17 September 2010

Ref: lt01089-95gwb_prh100917coastal processes responses.doc

SHELL COVE BOAT HARBOUR PRECINCT - CONCEPT PLAN APPLICATION AND ENVIRONMENTAL ASSESSMENT - SUPPORTING INFORMATION ON COASTAL PROCESSES, RESPONSE TO SUBMISSIONS

Figure D.7 – Maximum Wave Runup, North and South Shellharbour Beaches

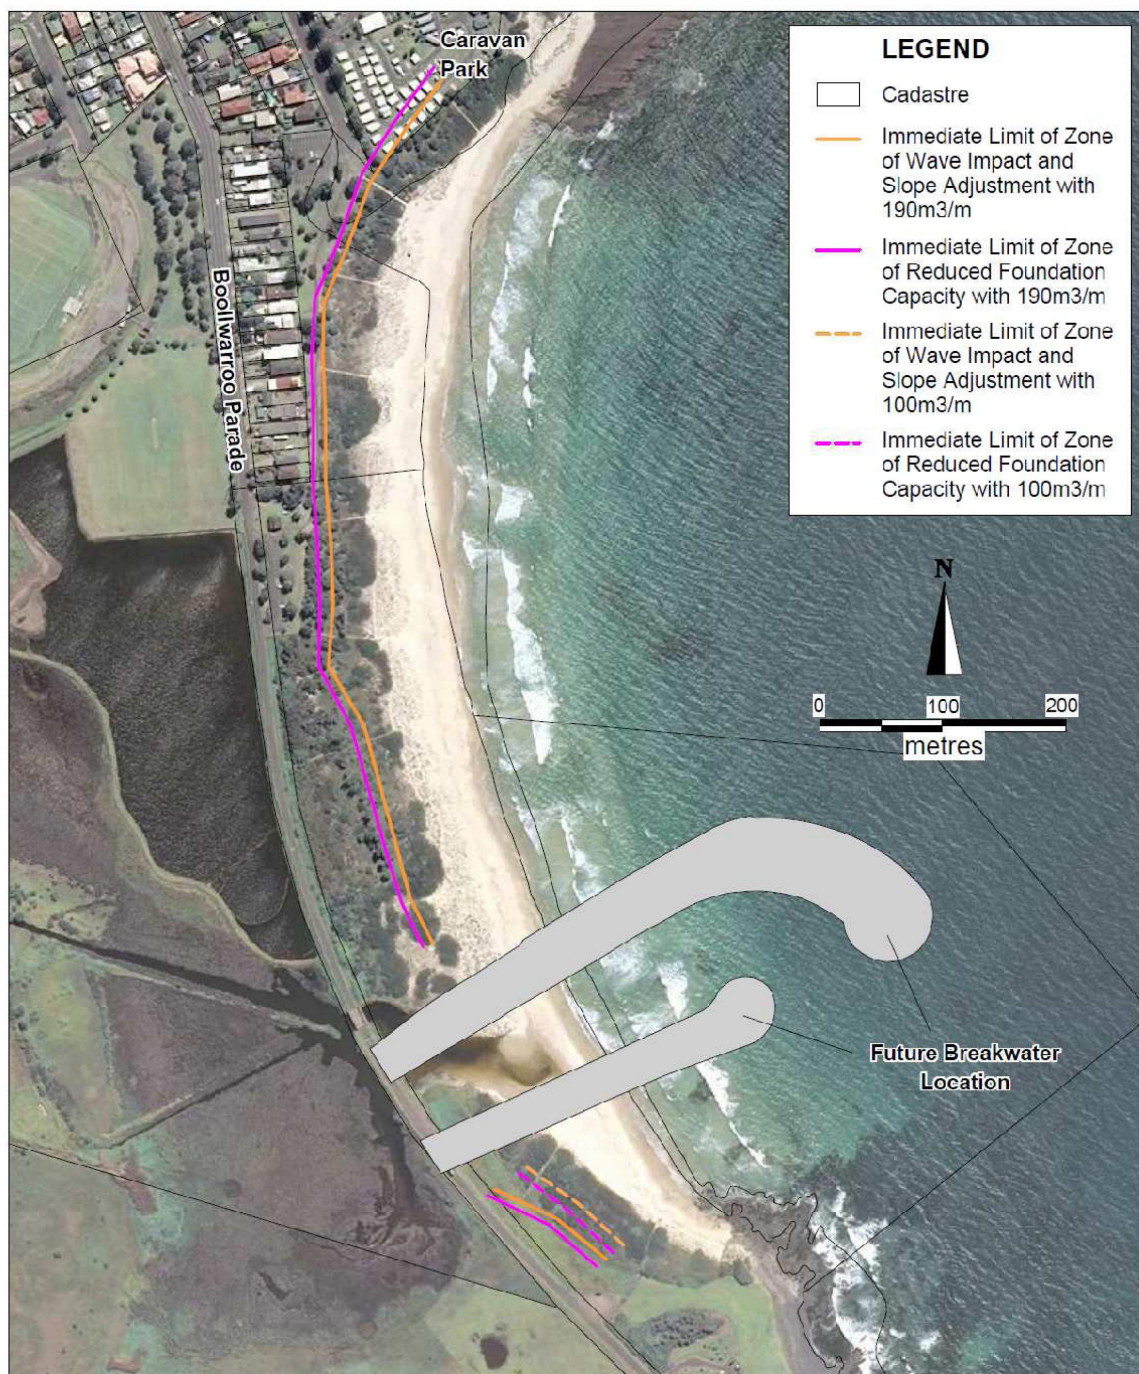
SMEC (2010) produced a map showing the extent of the maximum inundation at present along Shellharbour South Beach by simply shading in the foreshore area that was at a level of 4.6m AHD or less (Appendix D, Figure D.7). This is overly simplistic in that it does not take into account the attenuation, spreading out and infiltration processes that occur as wave runup overtops the crest of a dune and attempts to propagate further landward. Even so, the SMEC map showed that inundation would not extend beyond Boolwarroo Parade, ie would not extend to the proposed development areas within the Shell Cove Boat Harbour Precinct.

Figure D.25 – Immediate Hazard Zone at South Shellharbour Beach

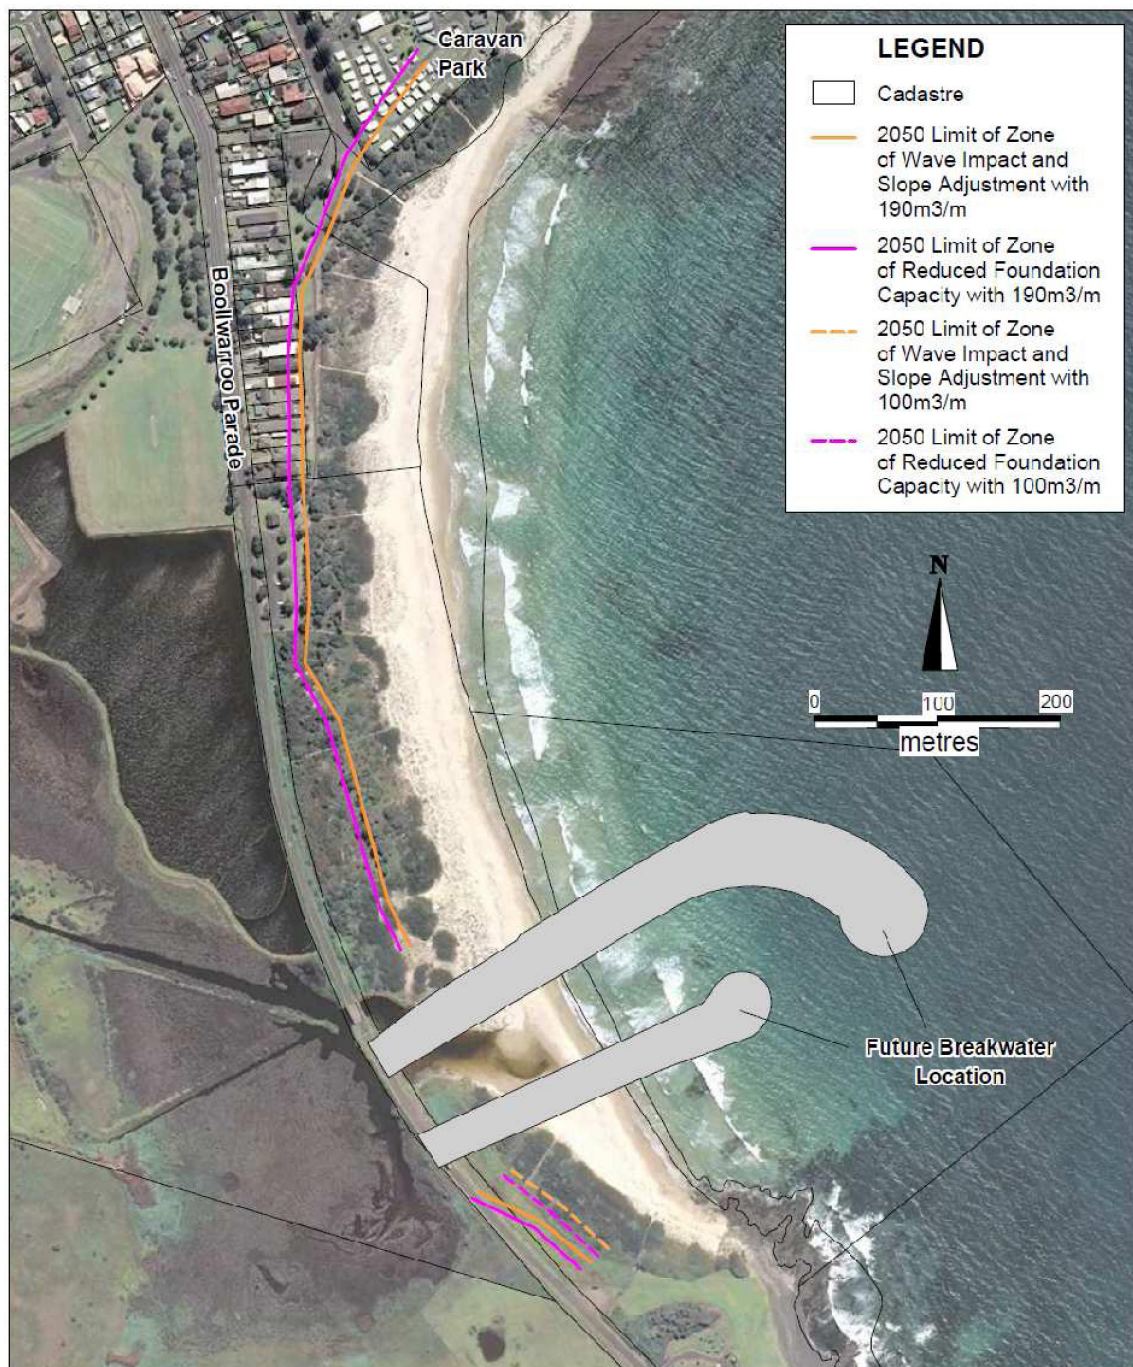
The hazard mapping produced by SMEC (2010) and shown in Figures D.25, D.28 and D.31 (refer **Attachment B** to this letter) demonstrates the following:

- north of the proposed boat harbour entrance:
 - the limit of the Zone of Reduced Foundation Capacity in the immediate, 2050 and 2100 planning periods are all seaward of Boolwarroo Parade
- south of the proposed boat harbour entrance:
 - the limit of the Zone of Reduced Foundation Capacity in the immediate, 2050 and 2100 planning periods, for a storm bite of 100 m³/m, are all seaward of Bass Point Road.

As such, while the general findings of the SMEC (2010) study are endorsed, the specific positions of the hazard lines are regarded as being too far landward.
